# Findings of Fact | Detached Accessory Dwelling Unit

## City of Portsmouth Planning Board

Property Address: 110 Aldrich Rd.

Application #: LU-23-174

**A-300**

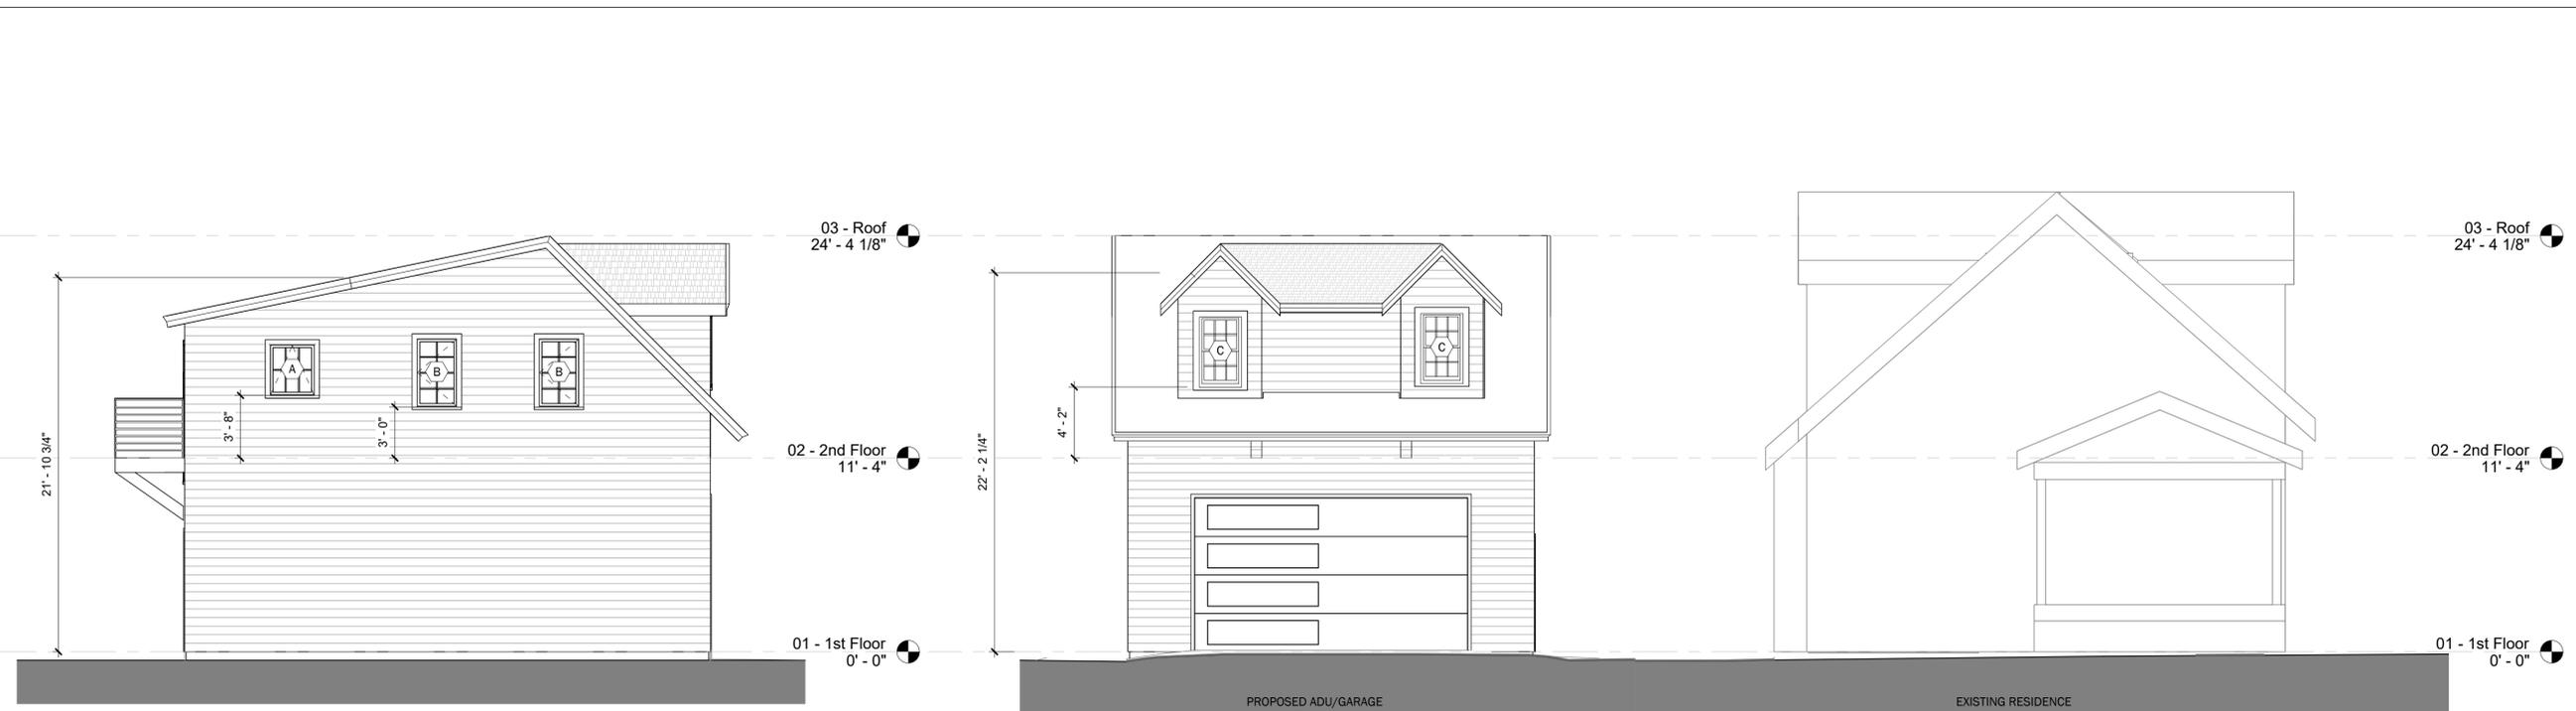
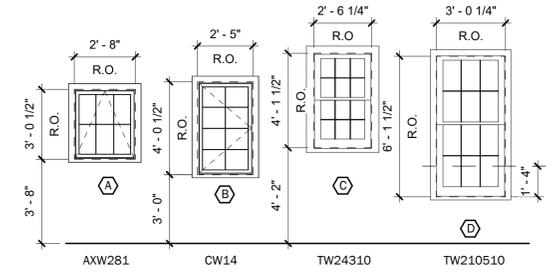
1) The stipulation in Section 10.814.436 that roof dormers, if provided, may occupy no more than 33% of any roof plane. As illustrated by the pictures of my existing house, and as directed by the Architectural Design Standards in Section 10.814.50, I am aiming to complement (and not mimic) my existing house with the ADU by “reflecting” the dormer design of the *side* of my existing house on the *front* of the DADU/garage. I think this is more aesthetically appealing than mimicry, and it allows for the DADU to have a long saltbox-style rear roof surface (flat and gently sloped) that is perfect for hosting a solar array, as the long axis of the building is aligned at almost exactly 180 degrees south. Dormers on the front also are well suited to the purposes of the interior floor plan. While the combined “doghouse”-”shed” dormer structure would account for 57% of the roof plane, its massing, character, details, and finishes will be entirely consistent with the existing house per the elements of 10.814.51. In short, I think it will look nice, quite complementary to my existing house.

2) The stipulation in Section 10.814.53 that if provided, all street-facing garage doors shall be limited to 9 feet. This seems a curious and arbitrary restriction for an ordinance that applies City-wide (perhaps there would be rationale in the designated Historic District). The primary reason I want a single 16’ wide garage door rather than two 9’ wide garage doors is for functionality, but related to my decision/goal of retaining a single width driveway and the existing front yard screening hedge. Doing so will require vehicles entering and leaving the garage to make a fairly sharp/tight ‘S’ turn. I would like to be able to back trailers into this garage occasionally, negotiating the same tight ‘S’ turn. I don’t want to have to deal (nor would any future owner or tenant) with a cosmetic structural obstacle such as the narrow divider between two single garage doors.

**A-100**

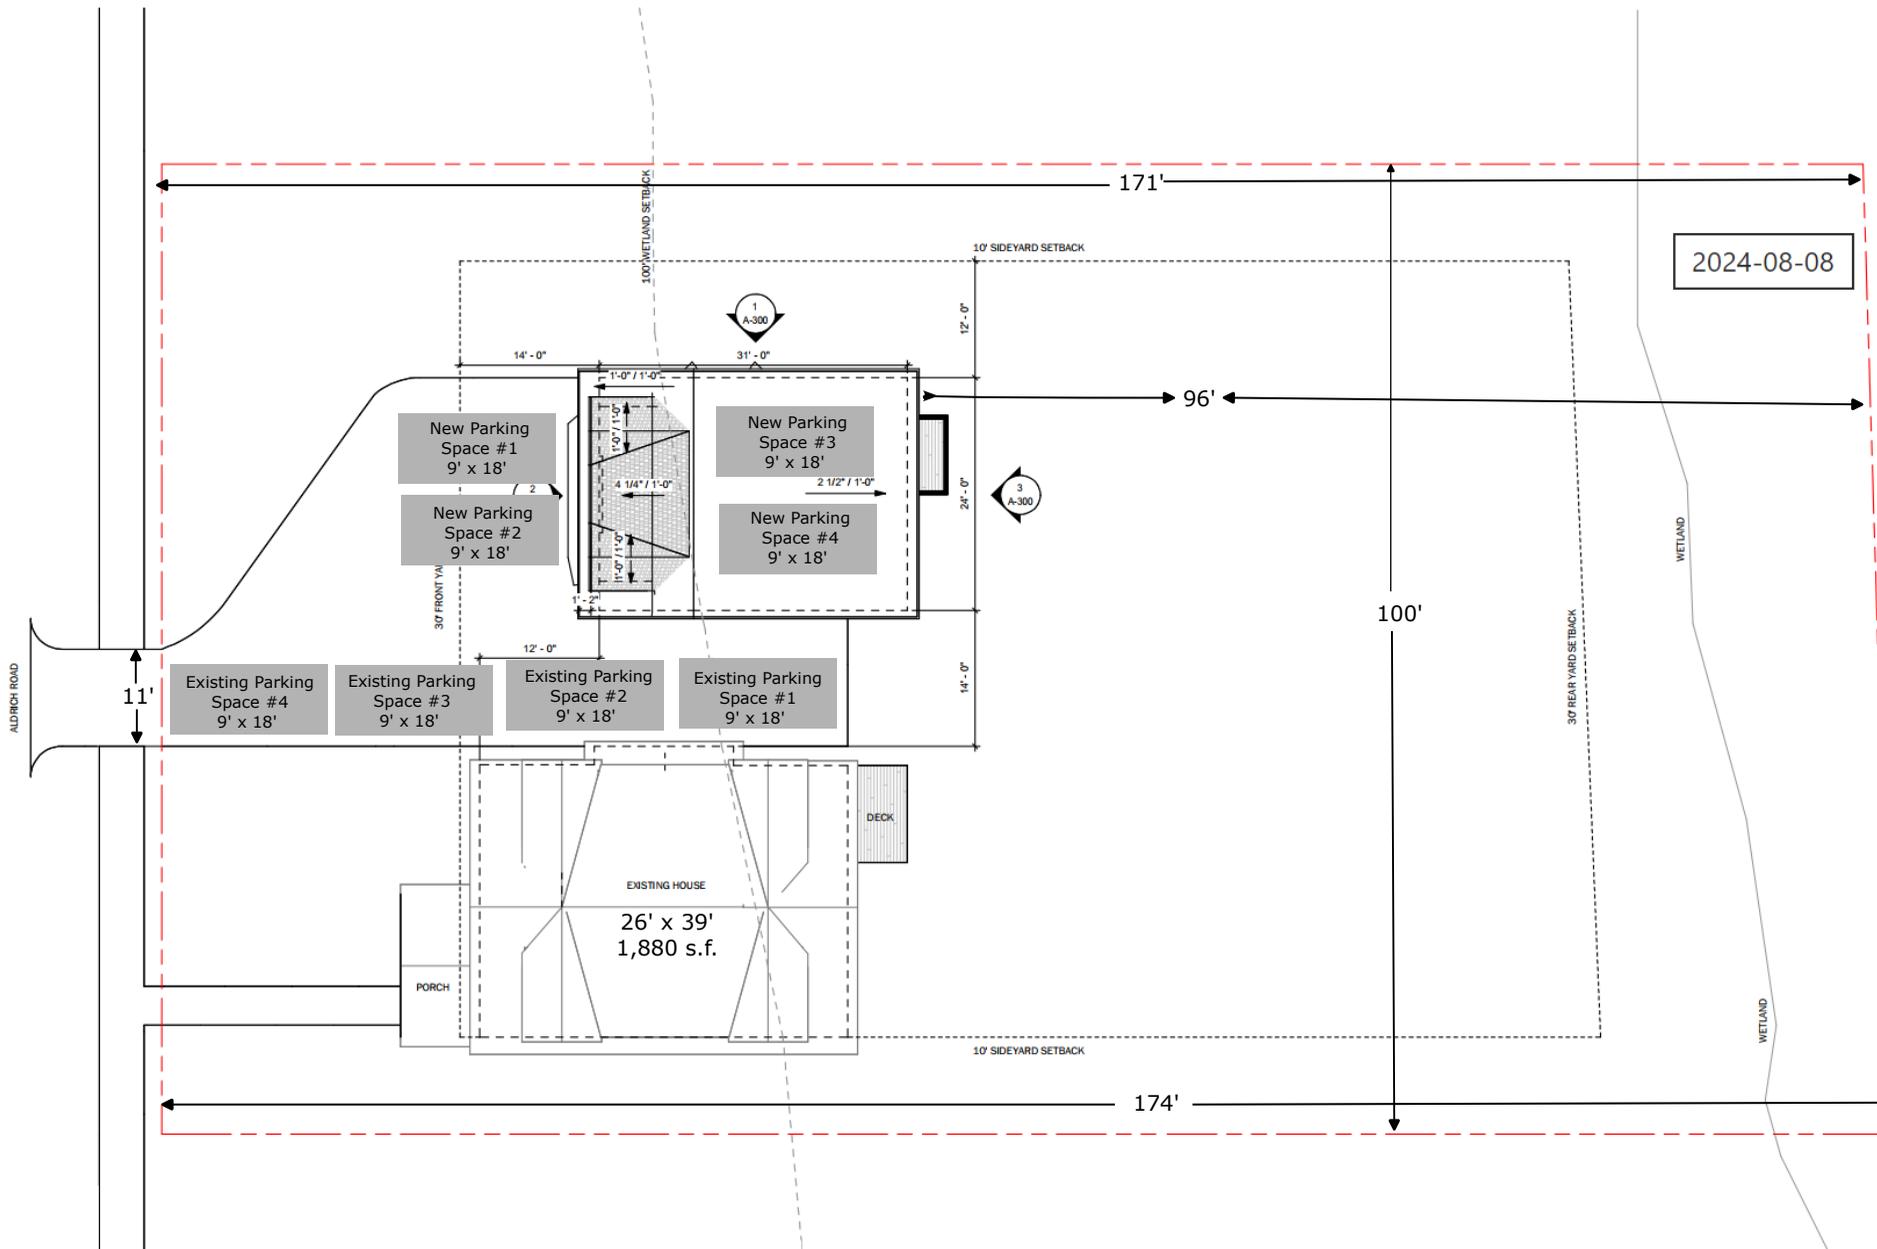
1. Applicant shall provide a clear delineation of the proposed driveways and their surfaces; including the proposed permeable paver driveway and the plastic-reinforced driveway. Specifications on the driveways should include any edging and/or plantings, and a cross-section of each driveway surface type shall be provided which should include the substrate material and its proposed depth.

2. Applicant shall provide a maintenance plan for the proposed driveway material and a maintenance plan for the plastic-reinforced driveway material.
3. Applicant shall include information in the final site plan for any drainage swales and/or drip edges proposed for drainage off the new garage roof. For the proposed drip edges,, please include a cross-section of the proposed drip edge construction, along with the substrate material and its proposed area and depth.

4. Applicant shall provide a planting plan that includes the location, size and species of the proposed plantings within the 25' vegetative buffer. This should include at least 10 shrubs of a native species.
